## **CITY OF WESTFIELD, IN**

### **Advisory Planning Commission Meeting Agenda**

**MEETING DATE: Monday, August 18, 2025 at 7:00 PM**

**Petition Number:** 2507-DDP-19  
**Project Name:** Central Indiana Insulation Building Expansion  
**Subject Site Address:** 1030 E. 169<sup>th</sup> Street  
**Petitioner:** Central Indiana Insulation  
**Representative:** William A. Cash  
**Request:** Detailed Development Plan review for a 3,500 square-foot enclosed industrial building addition on 1.77 acres +/- in the EI: Enclosed Industrial District.  
**Current Zoning:** EI: Enclosed Industrial District  
**Current Land Use:** Light Industrial  
**Approximate Acreage:** 1.77 acres +/-  
**Staff Reviewer:** Ryan Collingwood, Associate Planner

| Sheet Title | Sheet    |
|-------------|----------|
| SITE PLAN   | C200     |

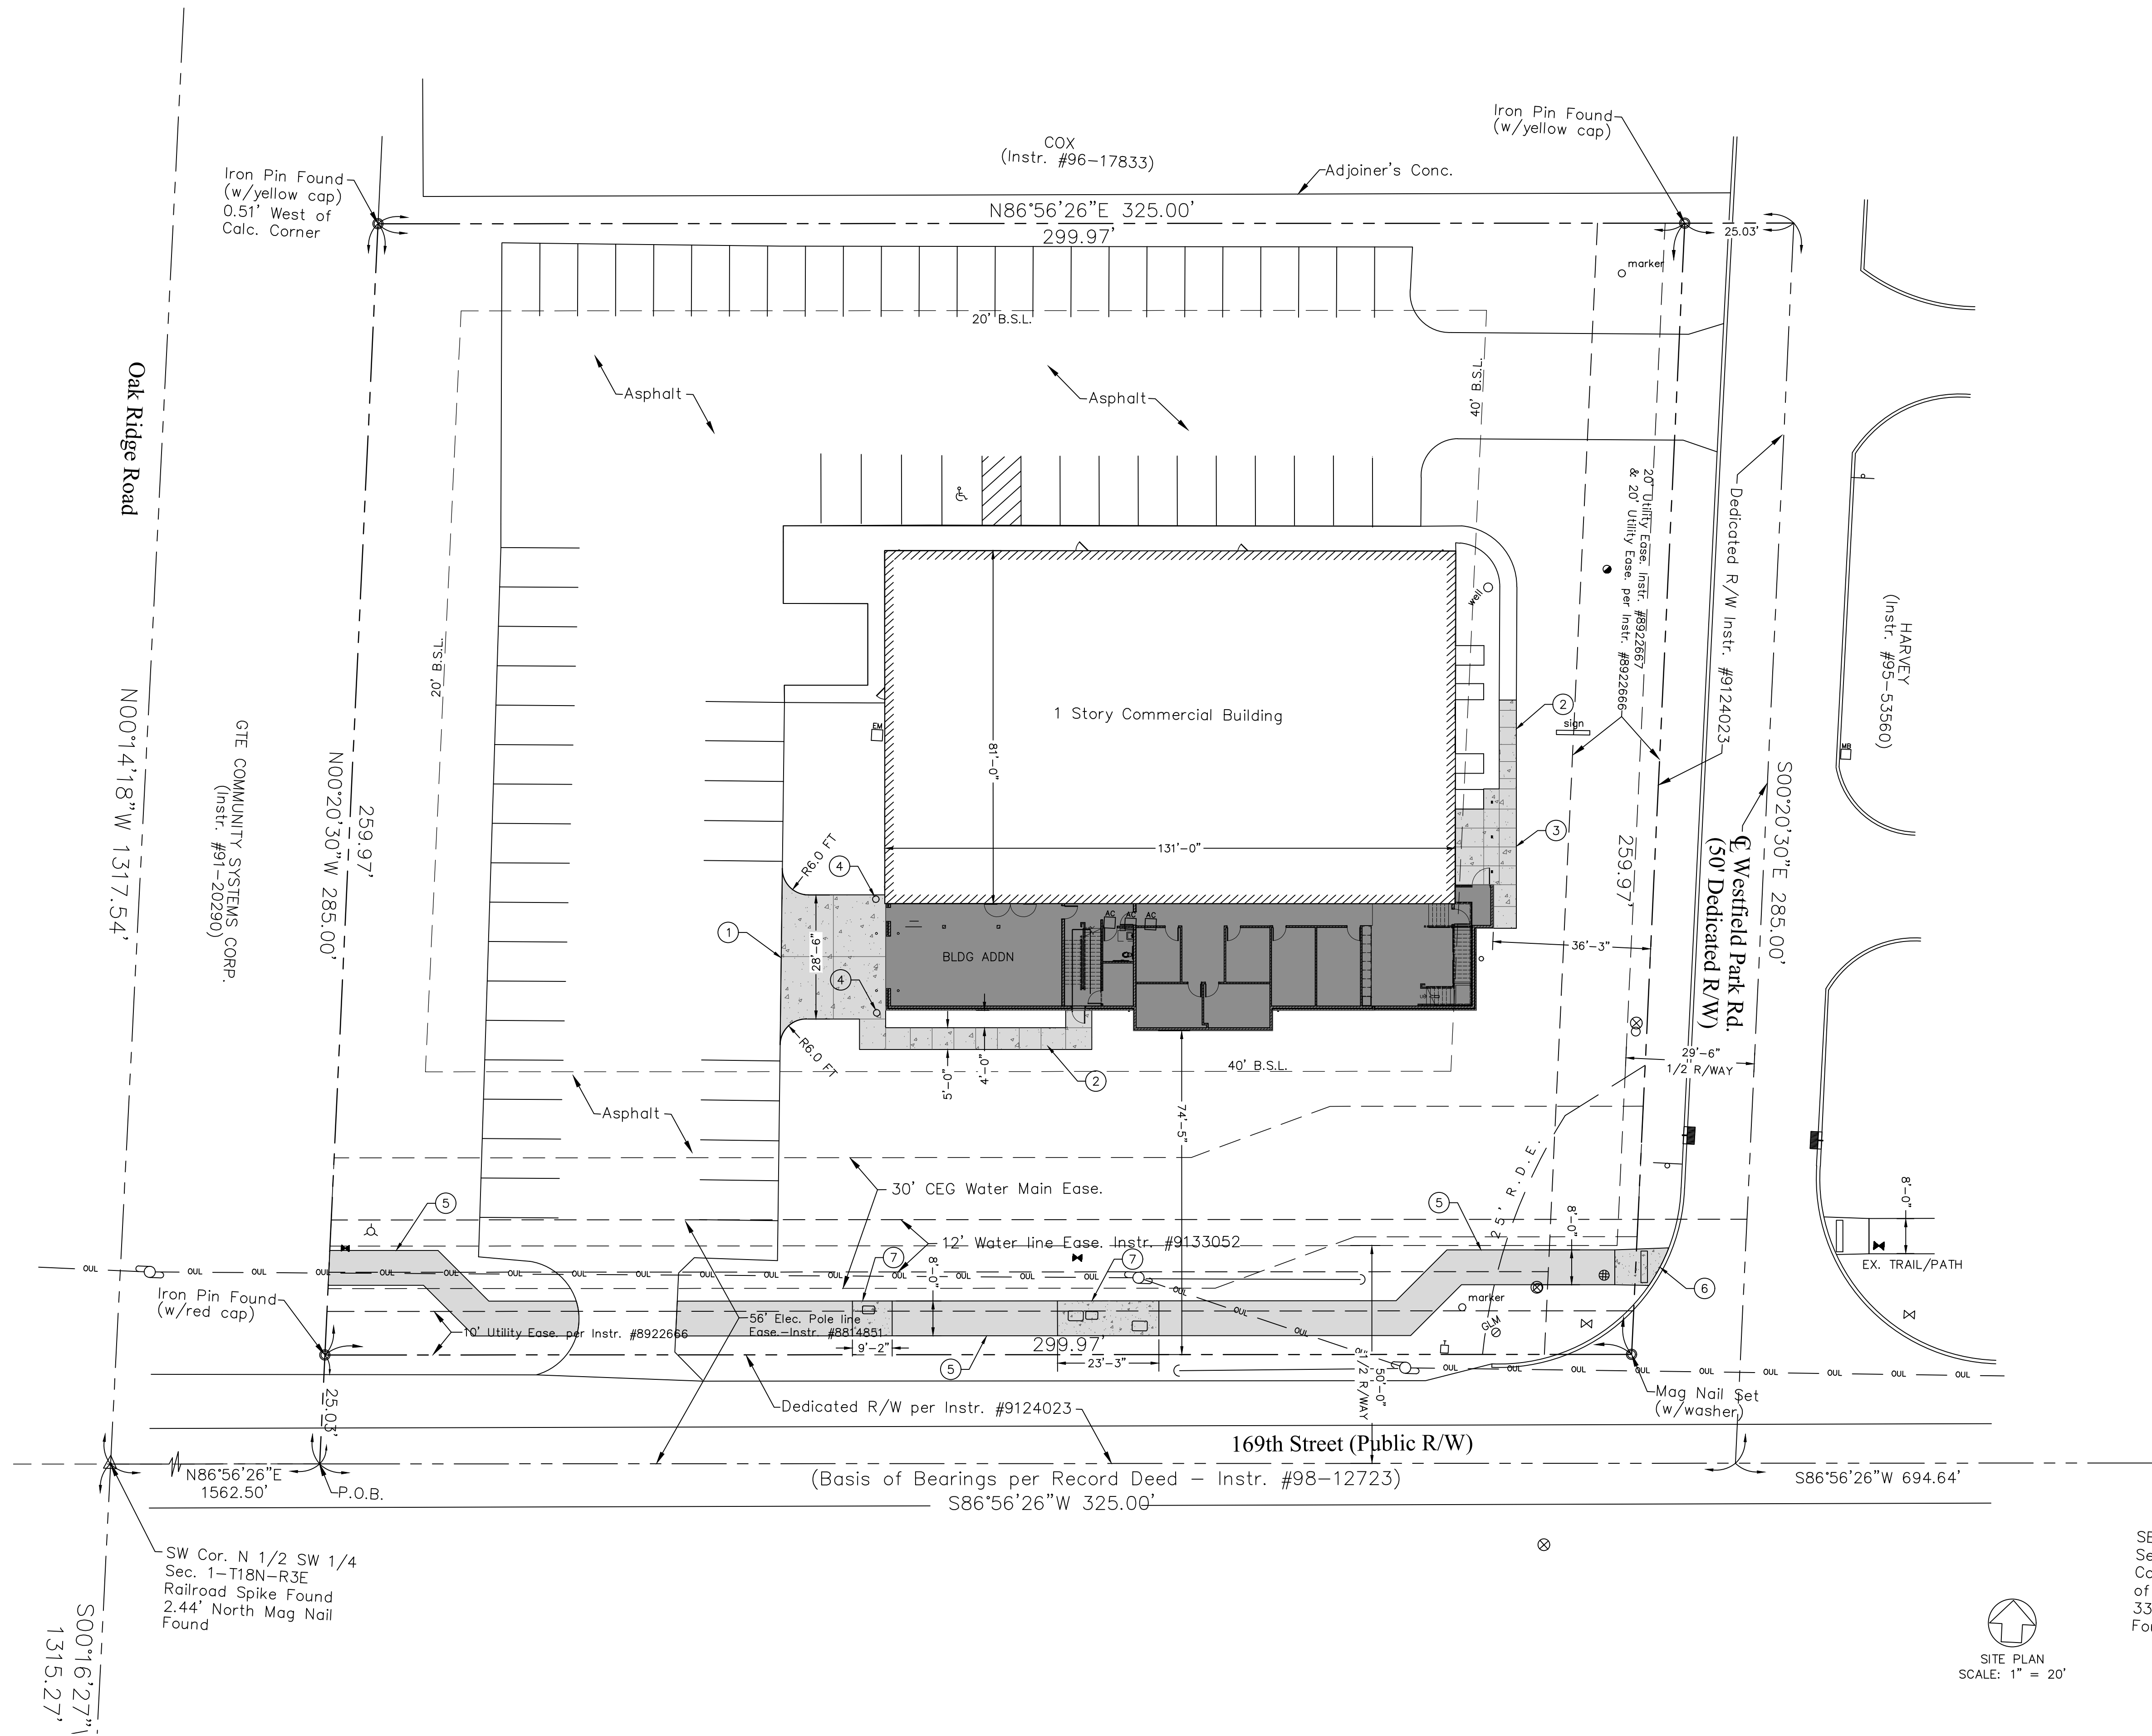
COMMENT: Please provide width
